CLOSURE PLAN FOR THE

ELKEM METALS BUILDING 78 SDMP SITE

ELKEM METALS COMPANY

February 26, 1997

## Figure 6 Soil Sample Locations

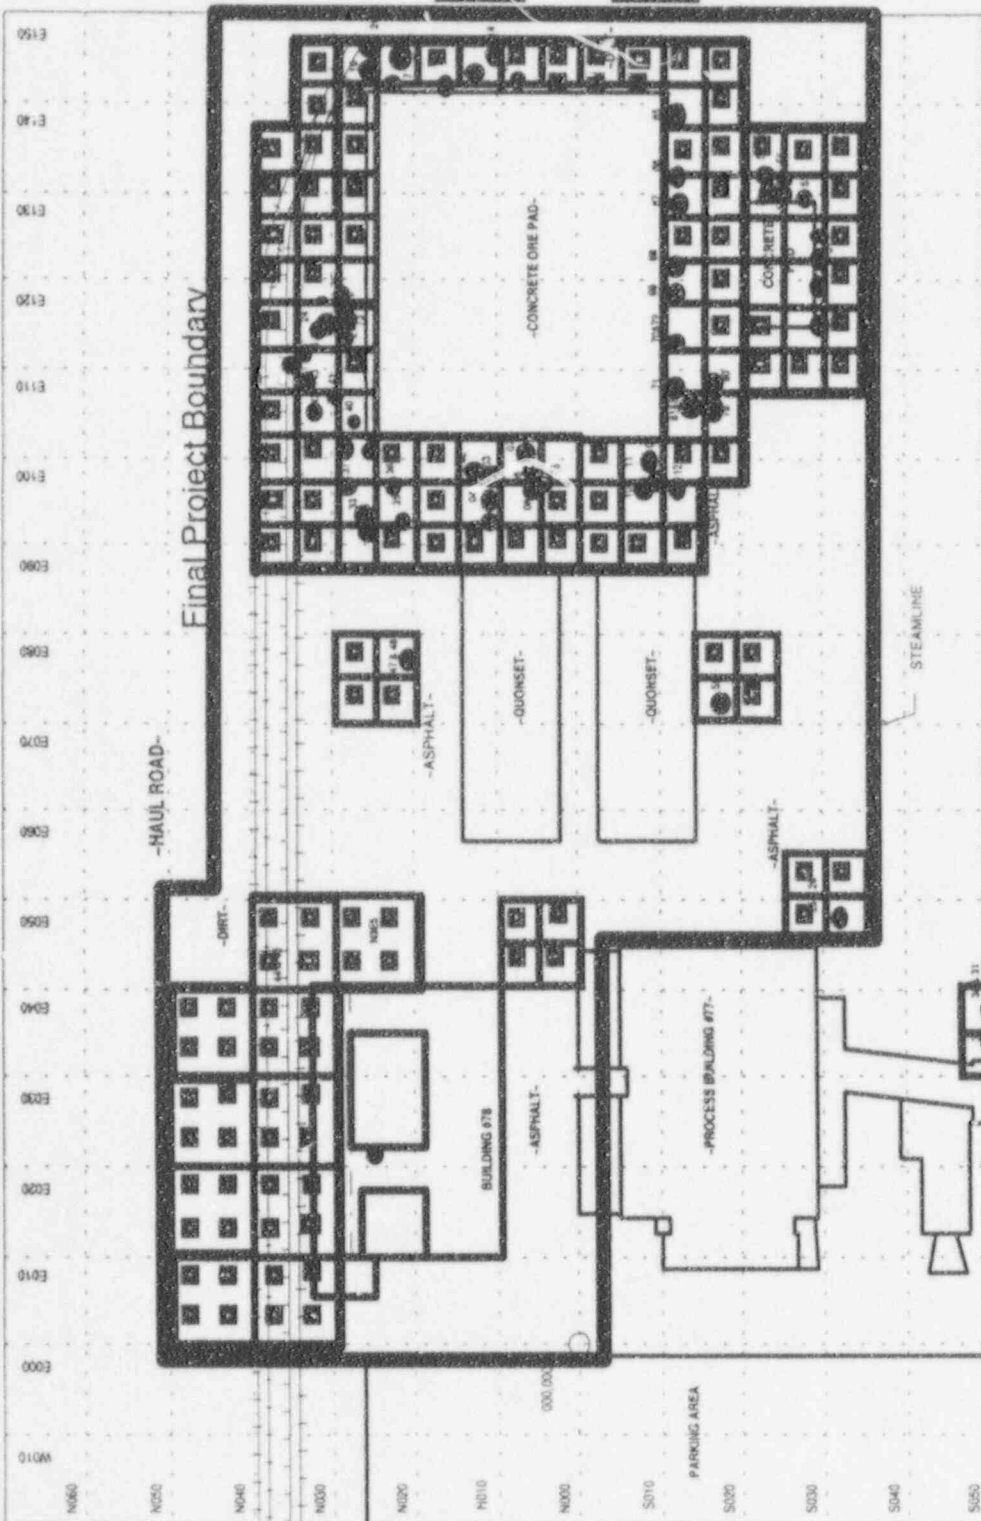
~~— The affected area around the concrete ore pad has several areas of soil remediation which have previously been sampled and surveyed for verification. To facilitate a stronger statistical basis for release of the site, the areas around the excavations will be sampled and surveyed for verification. A 10m X 10m grid system will be established across the affected area around the concrete ore pad and surrounding soils as depicted in Figure 5. The grid will be further divided into 5m by 5m quadrant blocks. Quadrant blocks which do not currently exhibit a verification soil sample will be sampled and surveyed. Any quadrant block which has one or more samples already representing the block will not be sampled again. If a quadrant block exhibits two or more samples, these samples will be averaged to represent the soil concentration within the block. Contact and 1 meter gamma radiation measurements will be made at locations equidistant between the center and each of the four corners of each of the remaining 10m X 10m grid blocks resulting in one sample per quadrant. Systematic soil samples will be collected at the same points (four per 10 meter grid block) in the affected area. The soil samples will then be composited with samples from the other quadrants of the 10m X 10m grid block. Thus, each quadrant will be represented in a composite for the 10m X 10m grid block. In the event a grid block has one or more quadrants already represented, the remaining quadrants will be composited and the data evaluated based on the number of quadrants represented by each composite.~~

~~— As discussed above, contact and one meter gamma radiation measurements will be made at each sample location. Up to four soil samples will be collected from within each 100 m<sup>2</sup> grid block, depending of the current representation of the 100 m<sup>2</sup> grid by previous soil samples. Soil sample analyses for verification samples will consist of isotopic thorium (Th 228, Th 230, Th 232), radium 226.~~

~~— The data for each composite will be evaluated along with the existing verification soil samples to determine if the average for each 10m X 10m grid block meets the release criteria. The data will be further evaluated to assure that the upper bound of the 95%~~

~~confidence interval for each grid meets the release criteria. The existing soil samples and those to be collected will also be correlated with contact instrument readings to demonstrate the relation between instrument reading estimates of soil concentrations and analytical results of soil samples for actual soil concentrations.~~

The affected area around the concrete ore pad has several areas of soil remediation which have previously been sampled and surveyed for verification. To facilitate a stronger statistical basis for release of the site, the areas around the excavations will be sampled and surveyed for verification. A 10m X 10m grid system will be established across the affected area around the concrete ore pad and surrounding soils as depicted in Figure 5. The grid will be further divided into 5m by 5m quadrant blocks. Quadrant blocks which do not currently exhibit a verification soil sample will be sampled and surveyed. Any quadrant block which has one or more samples already representing the block will not be sampled again. If a quadrant block exhibits two or more samples, those samples will be averaged to represent the soil concentration within the block. A 100 % scan of each affected 100 m<sup>2</sup> grid block will be conducted. Contact and 1-meter gamma radiation measurements will be made at locations equidistant between the center and each of the four corners of each of the remaining 10m X 10m grid blocks resulting in one sample per quadrant. Systematic soil samples will be collected at the same points (four per 10 meter grid block) in the affected area. Soil sample analyses for verification samples will consist of isotopic thorium (Th-228, Th-230, Th-232), radium-226.

The data for each sample will be evaluated along with the existing verification soil samples to determine if the average for each 10m X 10m grid block meets the release criteria. The data will be further evaluated to assure that the upper bound of the 95% confidence interval for each grid meets the release criteria.

Figure 6 illustrates the sample locations for additional soil surveys and sampling and surface contamination surveys and sampling discussed above. The locations were chosen as discussed to assure areas with limited existing data are fully represented.
